SERVICE BULLETIN

APPLICABILITY: 2015-16MY Legacy and Outback Models

NUMBER: 09-61-15

SUBJECT: Design Change to the Fuel Filler Door Assembly

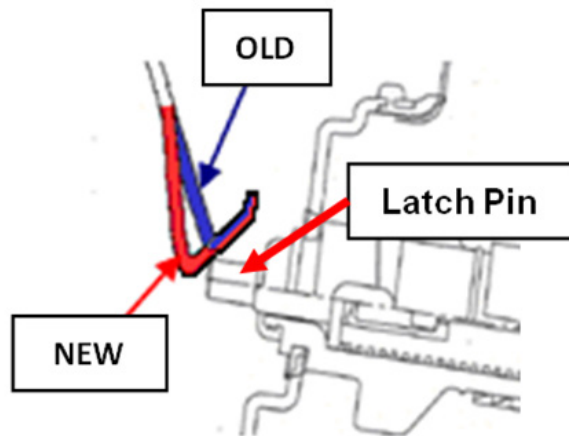
This bulletin announces a design change to the fuel filler door (saucer) assembly to address customer concerns of it being difficult to open and / or close. The striker portion's shape has been changed as shown in the cross-section illustration below along with the type of plastic material used in the construction of the saucer assembly.

The new saucer assembly was incorporated into production during August, 2015 starting with the following VINs: Legacy: **G005915** and Outback: **G208318**.

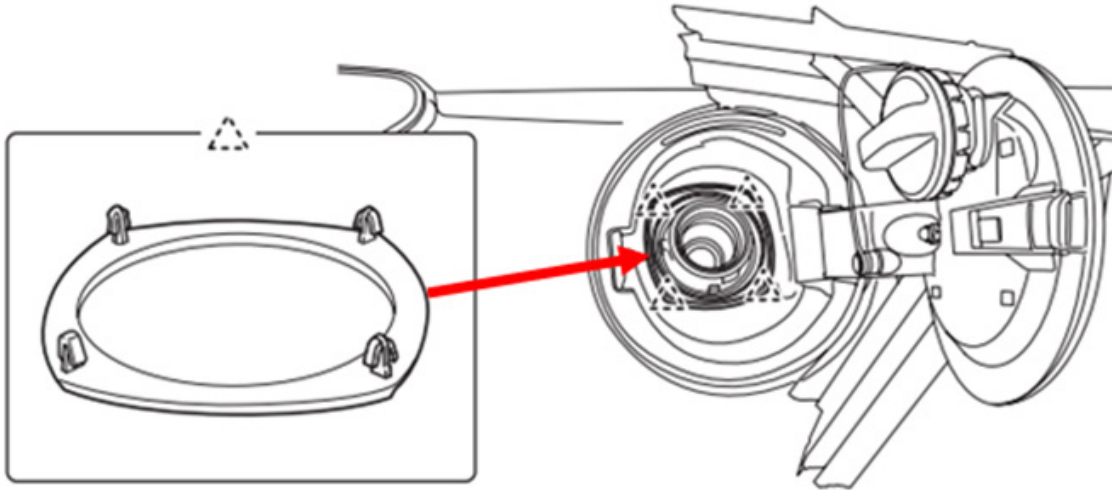
NOTE: The new plastic lock ring (seal) shown below **must** be replaced also as it is a one-time use part.

- **NEVER** attempt to re-use a previously installed part.
- **ALWAYS** take precautions to protect the vehicle finish when removing / installing the assembly.
